**Response to Stage 2
LRD Opinion
(Transport)**

Castlethorn Old Conna ULC

0126446DG0027

OLD CONNAUGHT PHASE A1 LRD

Figure 2-5 – Proposed Phase A1 Site Access & Egress Routing

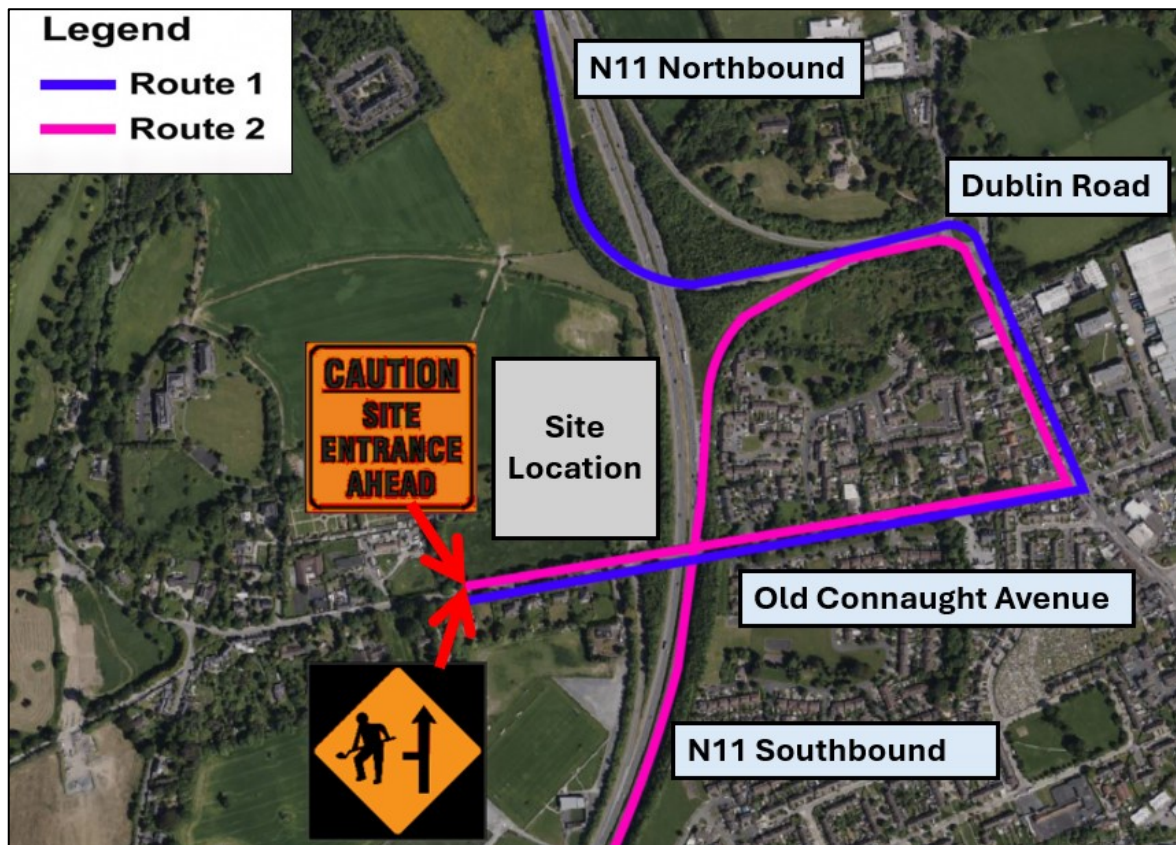
- Travel Plan
- Traffic Impact Assessment, demonstrating suitability of the proposed carriageway and junction design.
- Quality Audit (including Road Safety Audit & DMURS audit)
- Construction Management Plan including construction phase traffic management plan
- Cycle Audit (See Section 12.4.6.1 Paragraph 2 of the current County Development Plan)

Subject to formal agreement with DLRCC, the contractor shall use the routes indicated in Figure 2-5.

The routes identified are primarily the strategic road network to minimise disruption to sensitive local roads in accordance with best practice guidance. As summarised in above figure, Figure 2-5 all heavy construction vehicles to be instructed to use the R761, Old Connaught Avenue Road, via the M11.

Figure 2-7 - General Arrangement Drawing: As part of Stage 3 submission

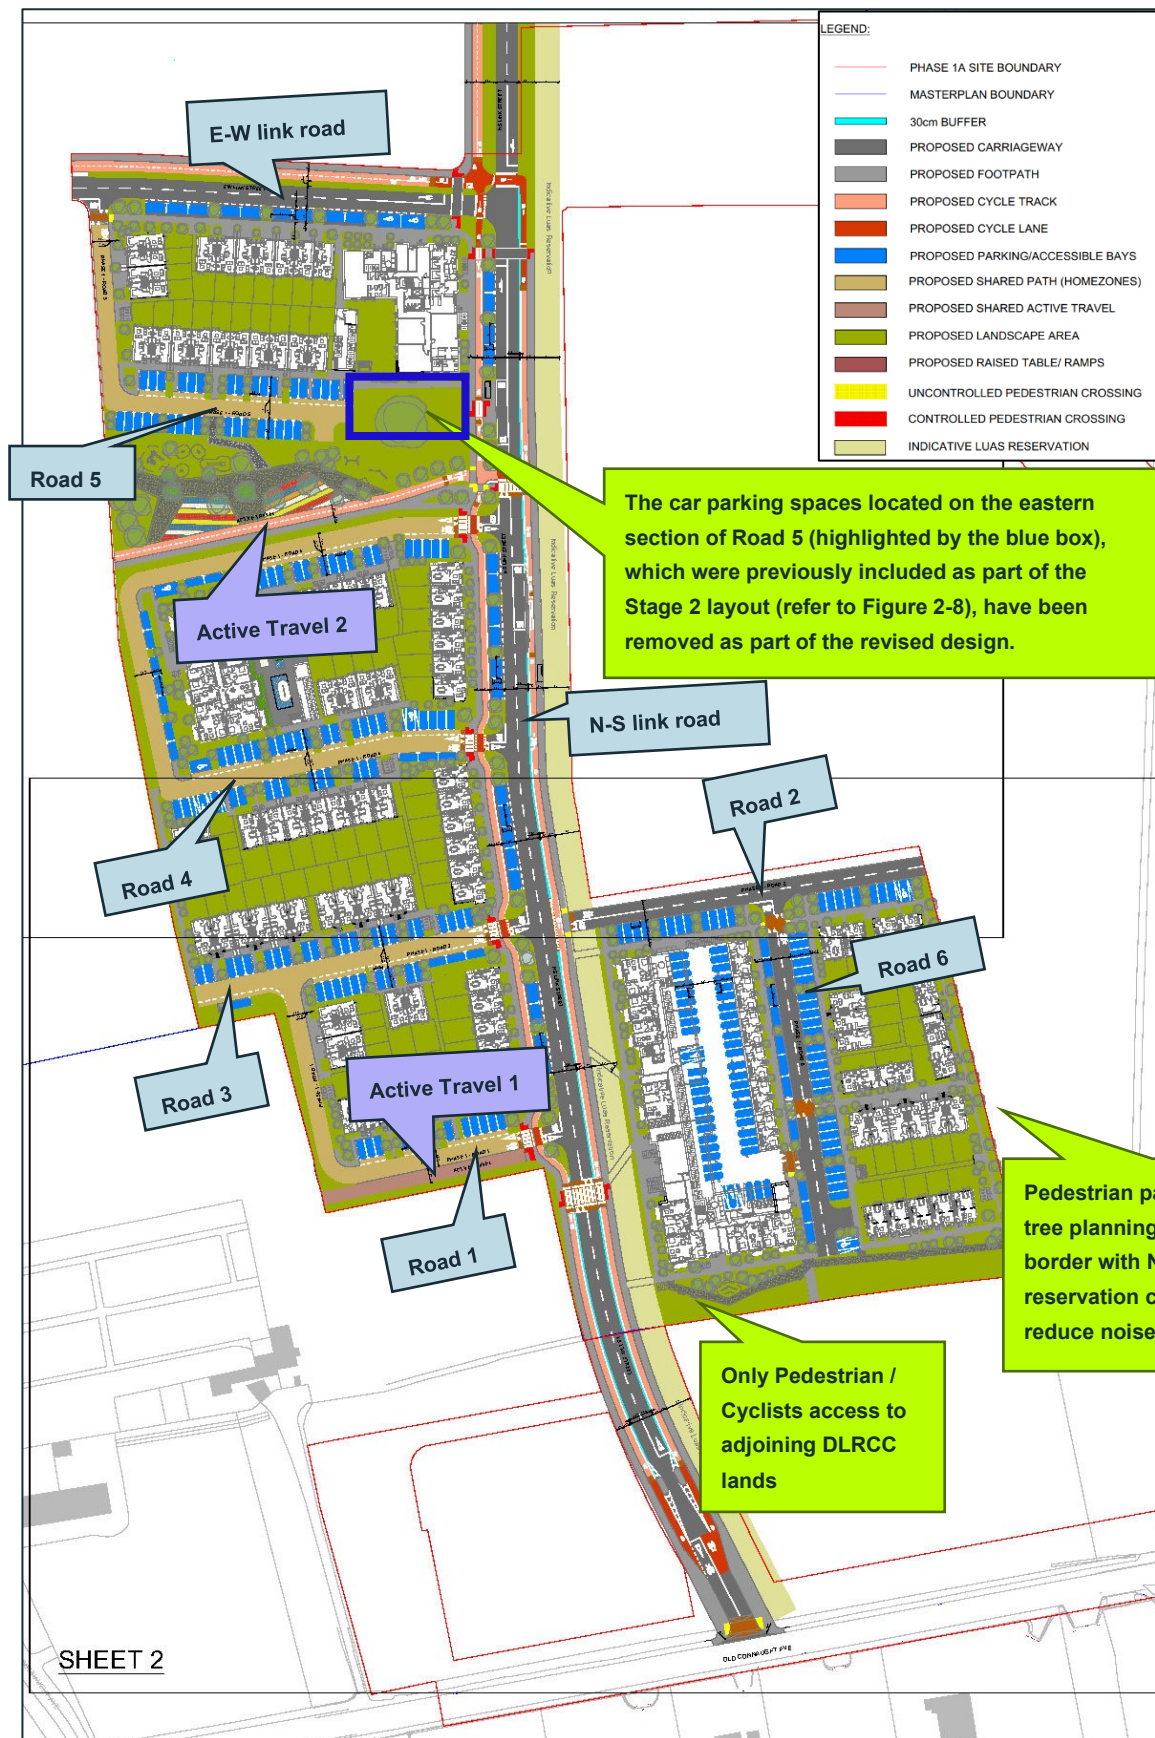
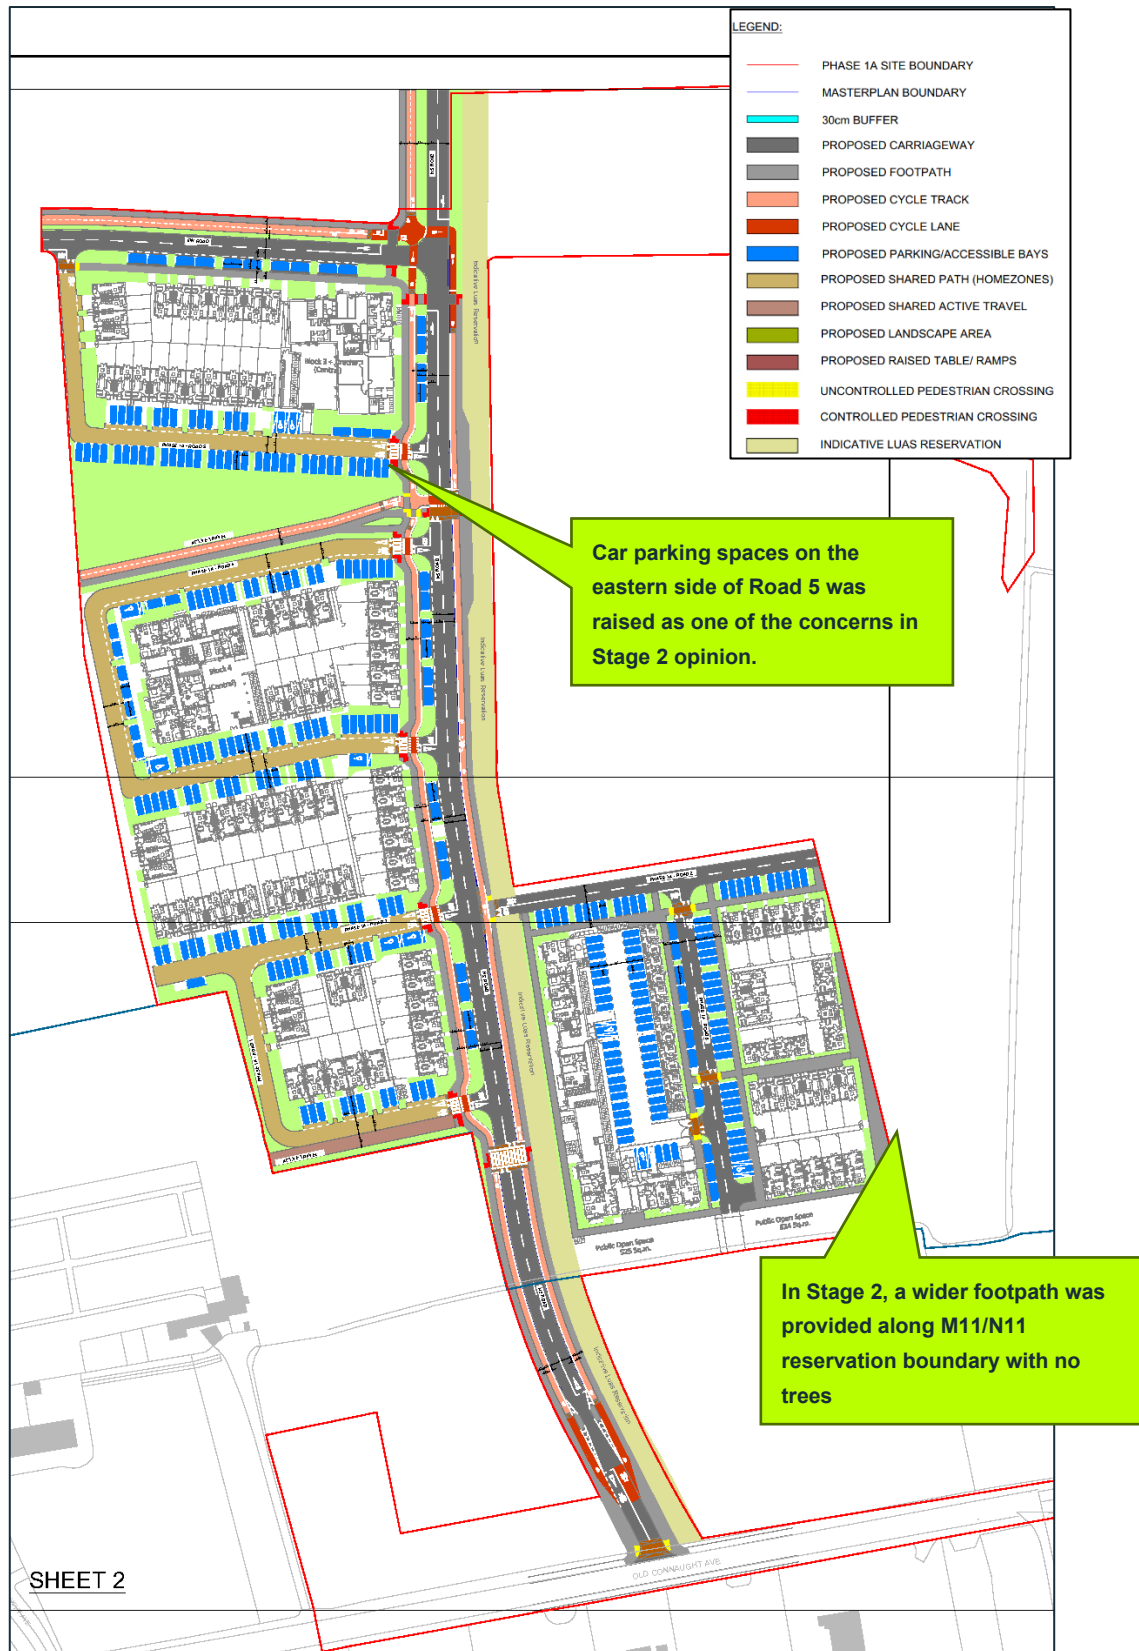
- **Opinion 3:** Pedestrian and cyclist access should be provided to the south-western site adjacent to Festina Lente.
 - **Response to Opinion 3:** An active travel connection (Active Travel Link 1, shown on Figure 2-7) has been provided along the southern boundary of the south-western development lands. This route has been designed to facilitate future connectivity and will be extended during subsequent phases of development to provide a direct link to Festina Lente.

- **Opinion 4:** Access to the public open space should be revised from a northerly direction (Block 3), as the proposed arrangement is likely to result in a traffic hazard due to poor visibility between pedestrians and vehicles/car parking.

- **Response to Opinion 1:** A dedicated pedestrian and cyclist link connecting the eastern development lands and the adjoining south-eastern DLRCC lands has been incorporated into the proposed layout (refer to Figure 2-7). However, this connection is intended solely for active travel users and does not facilitate vehicular movements. Restricting vehicular access at this location will limit through-traffic within the development, helping to maintain a high-quality residential environment and reinforcing the placemaking objectives of the scheme.

- **Response to Opinion 4:** This issue has been addressed through revisions to the road layout. The parking spaces previously provided on both sides of the eastern section of Road 5, located south-west of Block 3 in the Stage 2 scheme (refer to Figure 2-8), have been removed. These spaces have been replaced with a 1.5 m-wide pedestrian and cycle link providing access to the apartment building and adjoining public open spaces (refer to Figure 2-7).

- In addition, the previously proposed vehicular connection from Road 5 onto the North–South Link Road (Figure 2-8) has been removed. This connection is now reserved exclusively for pedestrian and cyclist movements (Figure 2-7), thereby reducing potential vehicle conflicts and improving safety and accessibility for active travel users.

Figure 2-10 - Overall Cross-Section of N-S link Road

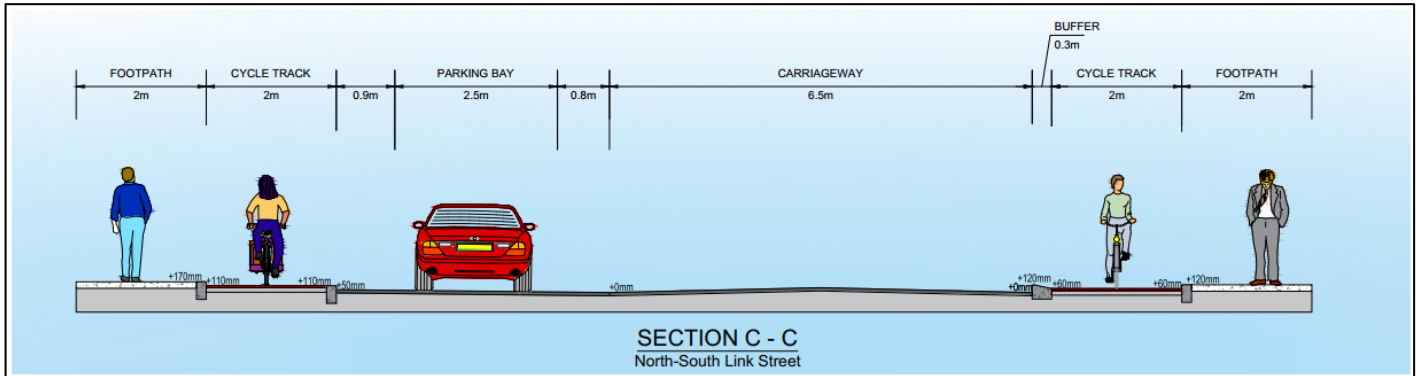
The NTA has reviewed the pre-planning material circulated on 6th March 2026, with a focus on the proposed reservation for the proposed Luas extension towards Bray. The Bray Luas extension remains a proposed Measure in the Greater Dublin Area Transport Strategy 2022-2042, but as work has not yet commenced on the scheme there is no Emerging Preferred Route or agreed cross-section for the scheme. The NTA would typically require a corridor reservation of 10 metres in width at this stage to allow the necessary flexibility in design development, within which a corridor of 7 metres in width would then be developed through the design process. The remaining elements of the 10 metre corridor would then be allocated to active travel, public realm or green infrastructure. In this case, the NTA is satisfied that the proposed 7 metre reservation with active travel facilities adjacent would provide sufficient space for a future light rail corridor through the lands if required, given the relatively flat topography and the straight alignment. A reservation of 7m only with no lateral flexibility could compromise the deliverability of a light rail line when it comes to more detailed design development.

To safeguard the future provision of a Luas corridor, a continuous **7 m-wide reservation** has been incorporated along the eastern side of the proposed North–South Link Road.

Notwithstanding this, the proposed cross-section (Figure 2-10) retains significant flexibility that would allow the safeguarded corridor to be widened in the future, should additional space be required as part of the detailed design of a future Luas scheme. Potential measures include:

- Reducing the carriageway width from **6.5 m to 6.0 m**, while remaining compliant with the guidance set out in Section 4.4.1 of DMURS;
- Reconfiguring the cycle infrastructure to provide a **3.0 m two-way cycle track with a 0.5 m buffer**, in place of the current arrangement of segregated one-way cycle tracks; and
- Removing on-street parking spaces, which currently occupy approximately **4.2 m** of the overall corridor width.
